Status: Decision Ren	dered - Reconsideration of ID 15705	
Appeal ID: 15732 Hearing Date: 8/23/17		Project Address: 685 SE Belmont St Appellant Name: Brian Cobb
Appeal Type: Building		Plans Examiner/Inspector: Brian McCall
Project Type: commercial		Stories: 6 Occupancy: R-2, M, B, S-2 Construction Type: I-A, III-A
Building/Business Name: Modera Belmont		Fire Sprinklers: Yes -
Appeal Involves: Reconsideration of appeal		LUR or Permit Application No.:
Plan Submitted Optic	n: pdf [File 1]	Proposed use: Apartments
APPEAL INFORM	ATION SHEET	
Appeal item 1		
Code Section	Section 907.5.2.2	
Requires	907.5.2.2 – Emergency voice/alarm communications systems. Emergency voice/alarm communications systems required by this code shall be designed and installed in accordance with NFPA 72	
Proposed Design	Two exit doors will utilize reduced egress width factors for occupant capacity. The Building will be sprinkled and utilized standard alarm system utilizing 907.5.2.1, 907.5.2.3, etc. where required bu not a voice/alarm communications system per 907.5.2.2.

#### Appeals | The City of Portland, Oregon

# Omission of emergeny voice / alarm communications system as a condition of reduced width at two

See Exhibit A: Level One Egress Plan

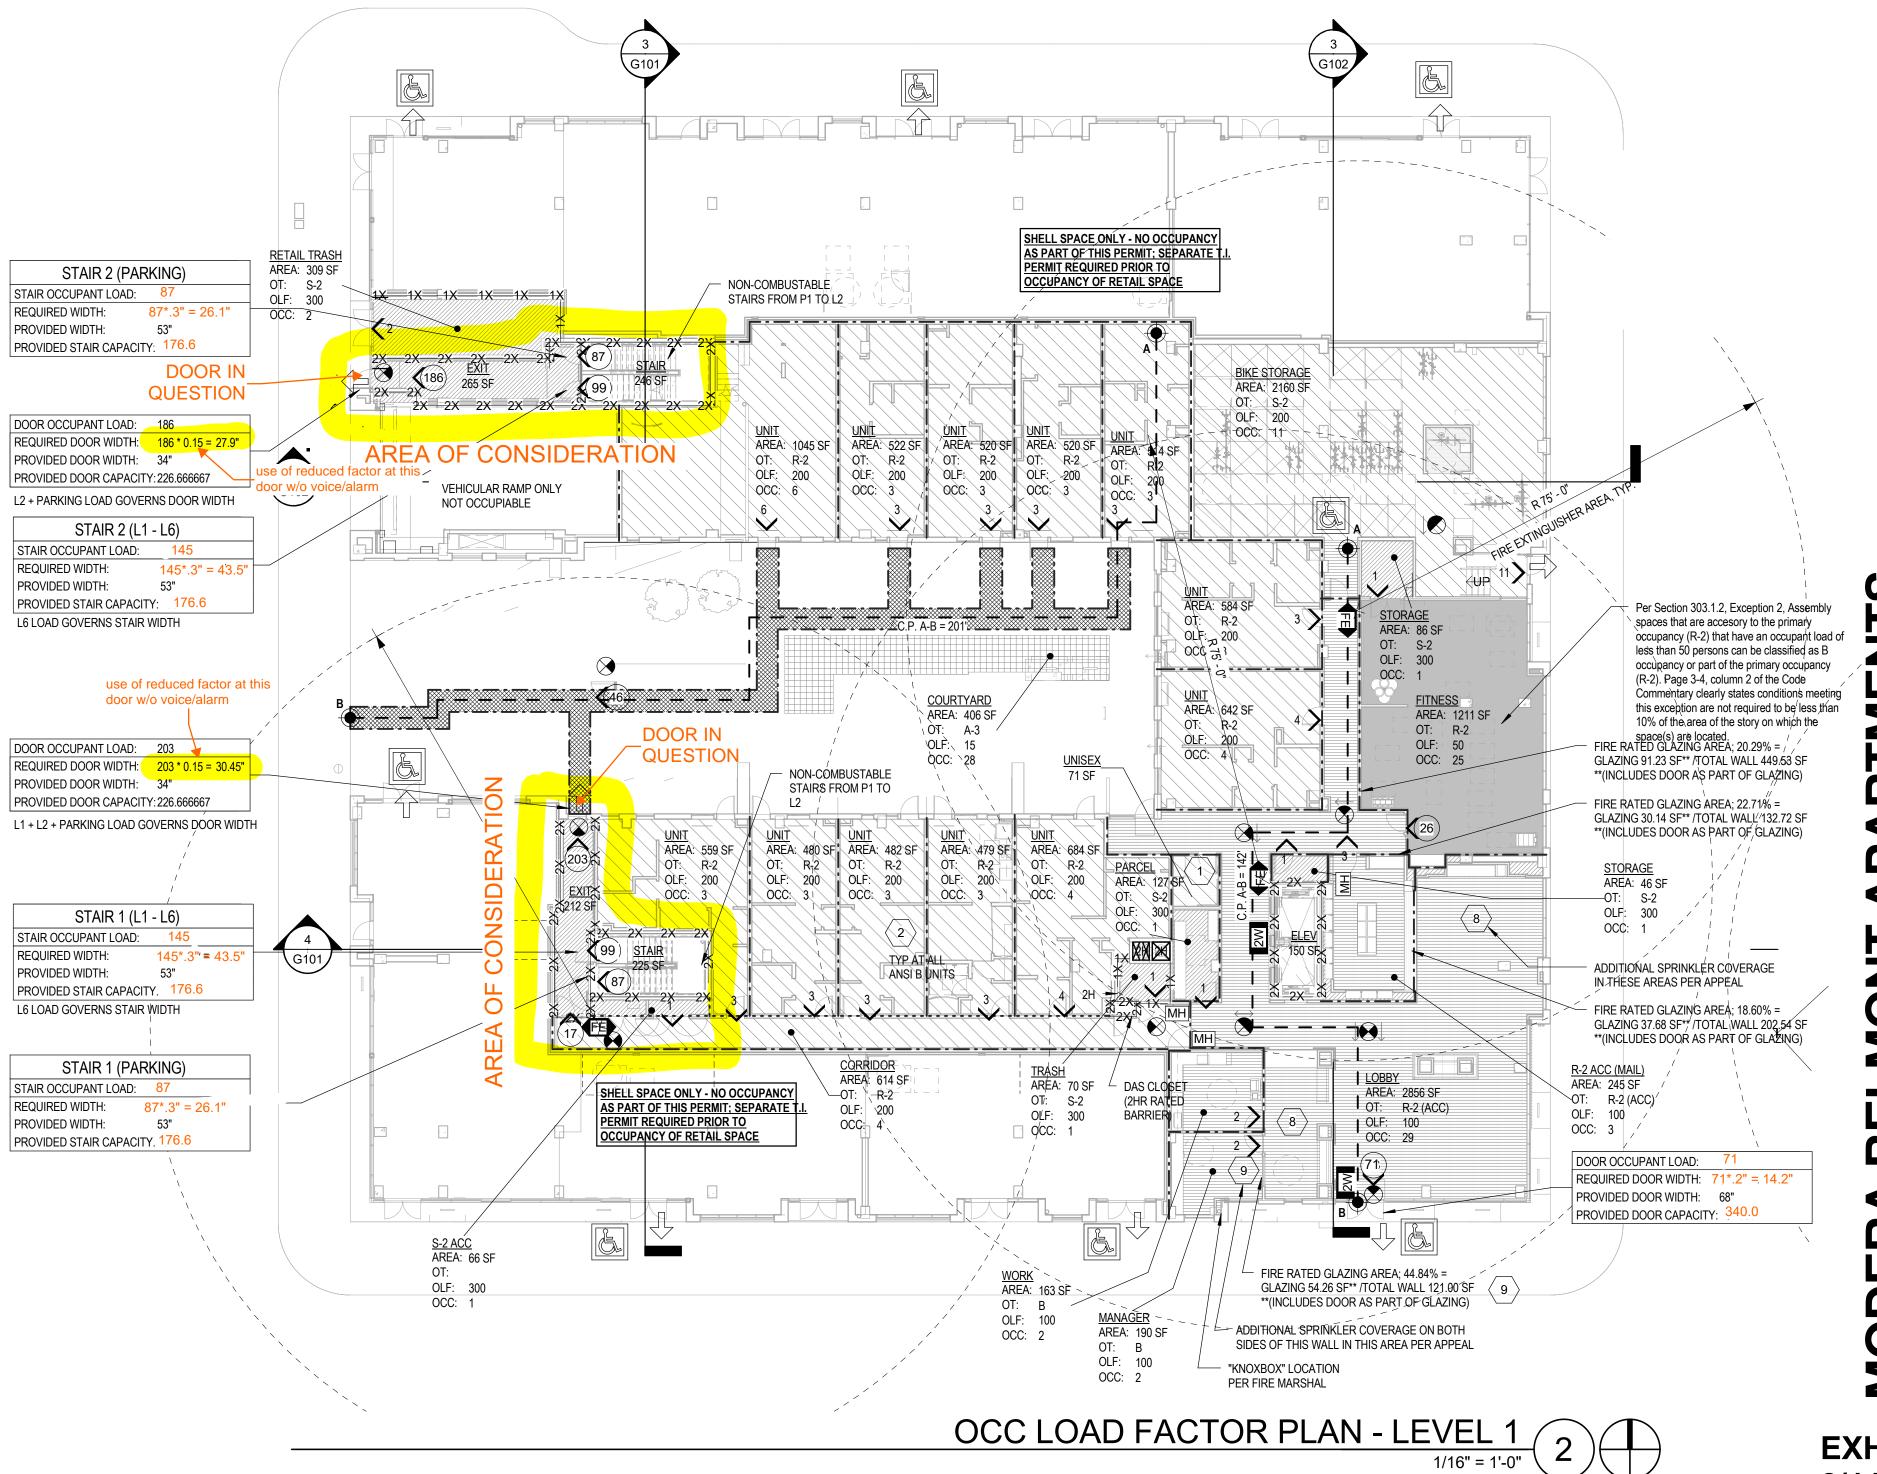
In summary, we are requesting that the emergency voice/alarm communication systems be removed as a requirement for the use of the reduced door egress width, i.e. 0.15"/occ, at the two doors in question. The remaining doors & stairs within the building will be calculated using the standard 0.3/occ & 0.2/occ factors which don't require sprinklers or voice/alarm communications.

All doors and stair egress widths comply with standard egress width requirements except the two doors being appealed.

The doors in question egress directly to the exterior, one of which is direct to the ROW sidewalk. Doors in question require the reduced egress factor primarily due to parking level occupant load. However, the parking level is primarily transient in nature (160 occupants in parking area out of 174 occupants on the entire level). The parking level is also for residents only meaning they know the building and can't be on the parking level and on the upper floors.

Emergency voice/alarm communication systems would be a burdensome requirement on the entire building for only two doors at the end of the egress system.

The building has smoke alarm systems within the corridor providing additional event notification and detection.

The Administrative Appeal Board finds that the information submitted by the appellant demonstrates that the approved modifications or alternate methods are consistent with the intent of the code; do not lessen health, safety, accessibility, life, fire safety or structural requirements; and that special conditions unique to this project make strict application of those code sections impractical.
